**Application Number:** DA2023/1527  
**Address:** Lot B DP 381427 , 187 Riverview Road, AVALON BEACH NSW 2107  
Lot LIC 577827 , 187 Riverview Road, AVALON BEACH NSW 2107  
**Proposed Development:** Demolition of an existing dwelling and Construction of a new dwelling including a swimming pool and relocation of existing inclinator

## NOTICE OF DETERMINATION OF A DEVELOPMENT APPLICATION

<b>Application Number:</b>	DA2023/1527 PAN-379444
<b>Applicant:</b>	Vanessa Louise Lenthall 187 Riverview Road AVALON BEACH NSW 2107
<b>Property:</b>	Lot B DP 381427 187 Riverview Road AVALON BEACH NSW 2107 Lot LIC 577827 187 Riverview Road AVALON BEACH NSW 2107
<b>Description of Development:</b>	Demolition of an existing dwelling and Construction of a new dwelling including a swimming pool and relocation of existing inclinor
<b>Determination:</b>	Approved Consent Authority: Northern Beaches Council
<b>Date of Determination:</b>	07/05/2024
<b>Date from which the consent operates:</b>	07/05/2024
<b>Date on which the consent lapses:</b>	07/05/2029

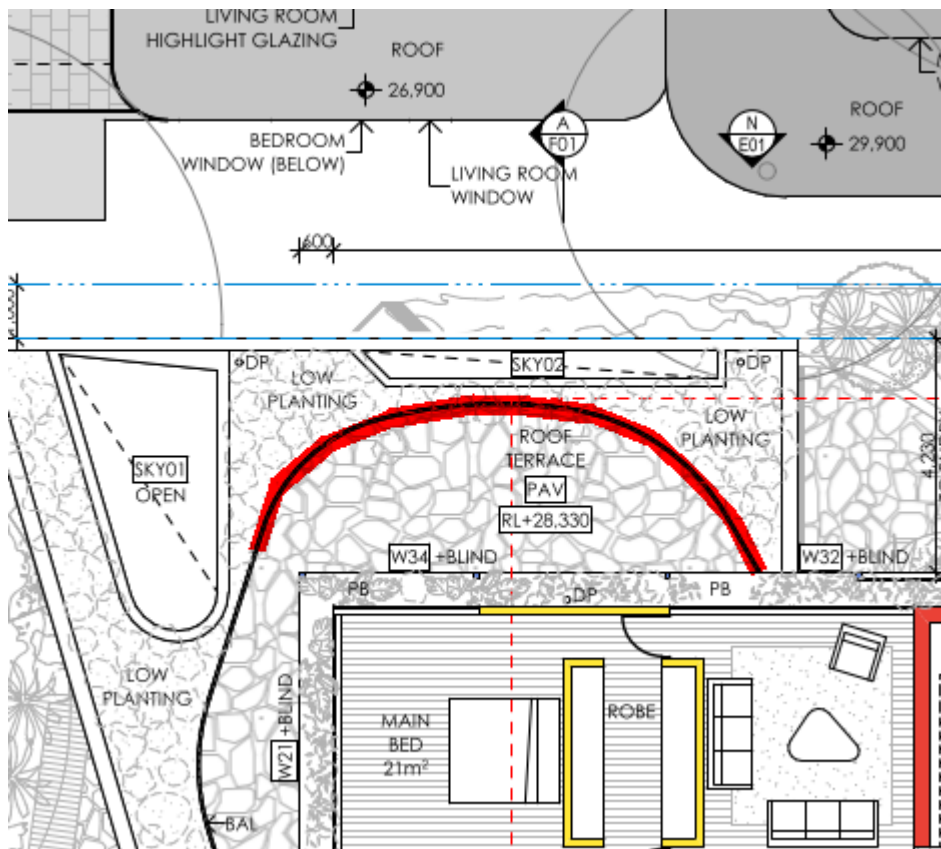
#### 19. Amendments to the approved plans

The following amendments are to be made to the approved plans:

Alternatively, a planter box may be provided on the inside of the red line. The planter box is to have a minimum height of 1.4m, a minimum width of 1.5m, and planting that grows to a height of at least 1.8m above finished terrace level.
